Application of Joseph Cooley, Esq. to rezone property from RE (Residential Estate) District to M (Light Industrial) District to allow a warehouse/office use, at 2346 Pine Mountain Street. PETITION NO: N7. Z-21-1244581 2021-2114

AGENDA ITEM: 2021-2114 Z-21-1244581 RECOMMENDED CONDITIONS (AS OF 3-14-21)

STAFF ANALYSIS

Case No.:	Z-21-1244581	Agenda #: N7	
Location/Address:	2346 Pine Mountain Street	Commission District: 5 Super District: 7	
Parcel ID:	16-168-01-008		
Request:	To rezone the subject property fr Industrial) for an office/warehou	om the RE (Residential Estate) District to M (Light se facility.	
Property Owner(s):	MH Lithonia Holdings, LLC & Neisem Properties, LLC		
Applicant/Agent:	Joseph Cooley, Esq.		
Acreage:	1.8 acres		
Existing Land Use:	Undeveloped		
Surrounding Properties:	To the north of the subject property are residential parcels, to the south are undeveloped parcels, to the west are residential and undeveloped parcels, and to the east is a truck lot.		
Adjacent Zoning:	North: M South: M East: M West: M		
Comprehensive Plan:	Suburban (SUB)	Consistent Inconsistent	
Proposed Density:	N/A	Existing Density: N/A	
Proposed Square Ft.: TBD		Existing Units/Square Feet

Proposed Site Plan Sketch – Warehouse & Office 5,000 s.f. office/warehouse

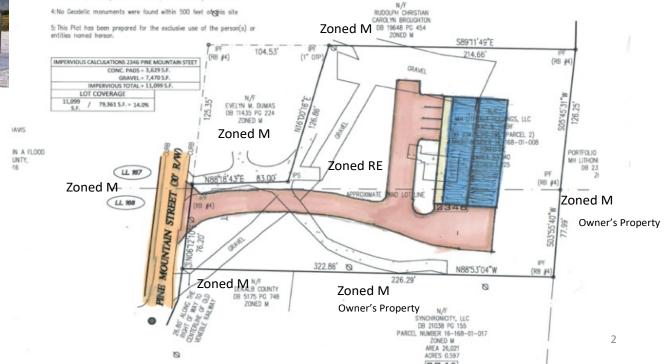
However, the applicant informed staff that a warehouse/office is the intended use for the subject property and has introduced a conceptual plan. The conceptual plan lacks enough detail to be fully evaluated at this time. Therefore, the Department of Planning and Sustainability recommends full-cycle deferral of the request.

On the other hand, should the Board of Commissioners approve the request, the Department of Planning and Sustainability recommends the following conditions:

- 1. The subject property shall be consolidated with adjacent properties under common ownership or designed to facilitate shared access through parcels with access to Turner Hill Road (or the spur road).
- 2. Ingress/egress to/from the site shall not include Pine Mountain Street.
